UNITED STATES PATENT AND TRADEMARK OFFICE

APPLICATION NO.	FILING DATE	FIRST NAMED INVENTOR	ATTORNEY DOCKET NO.	CONFIRMATION NO.
10/600,379	06/20/2003	Steve B. Taylor	2236.001	7549

Office Action Summary

DETAILED ACTION

Patent 5697320 (see marked-up figures below).

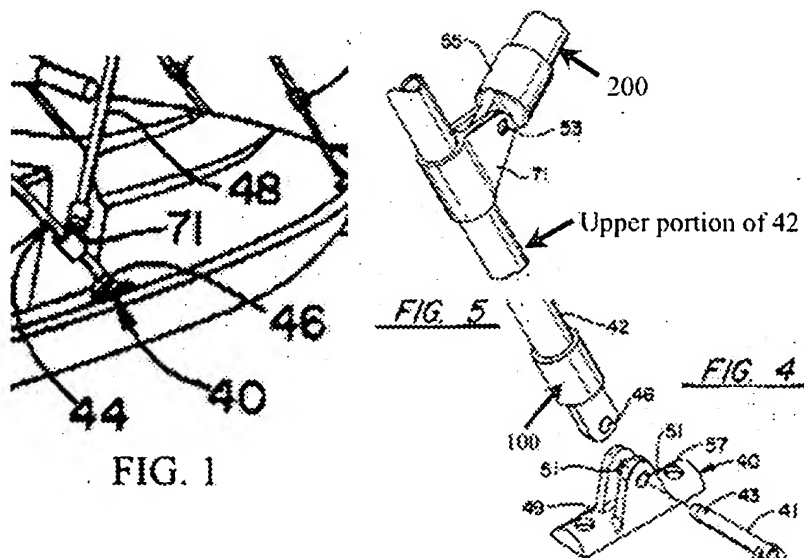
Claim 1. Murray discloses (figs. 1, 4, 5) a variably positionable coupler mountable on a curved surface, comprising: a base (40) formed with an upper side and a lower side, wherein the lower side is a substantially flat planar surface; means (57) for mounting the base on the curved surface (curved surface of the watercraft as seen in figure 1); a tub (100) adjustably connectable

to the base; a plug [42 (including upper portion of 42) and 71] repositionably attachable to the tub; a neck (55) rotatably insertable in the plug [42 (including upper portion of 42) and 71], wherein the neck is formed for securing a shaft (200) to the neck; and a clevis mechanism (clevis connection between 55 and 71) slidably and demountably engageable with the plug and the neck. (Note that while the Murray curved surface does not curve at its point of contact with element 40, it does curve elsewhere and is thus a curved surface within the broadest reasonable interpretation of the claim language).

Claim 2: Murray discloses opposing yokes (tab portions of 40 receiving 41) monolithically extending at substantially right angles from the upper side of the base.

Claim 3. Murray discloses one or more bores (51) formed in the base with a proximal end and a distal end, and further wherein the one or more bores are shaped for removable engagement with a bolt (41). The word "bolt" is taken by the Examiner to mean, "a metal rod or pin for fastening objects together" in accordance with Merriam-Webster's Collegiate Dictionary Tenth Edition.

The applicant argues that the Murray elements, as referred to by the examiner in the marked-up drawings above, do not read upon that applicant’s claims because the elements of figure 4 and figure 5 do not form a connected assembly. This is not persuasive. Note that Figure 5 is a close-up depiction of an area of figure 1 near element 71. Further note that Figure 4 is a close-up depiction of an area of figure 1 near element 40. As clearly shown in figure 1, the element 71 area is directly above and connected to the element 40 area. Thus, the elements of figure 5 are directly above and connected to the elements of figure 4.
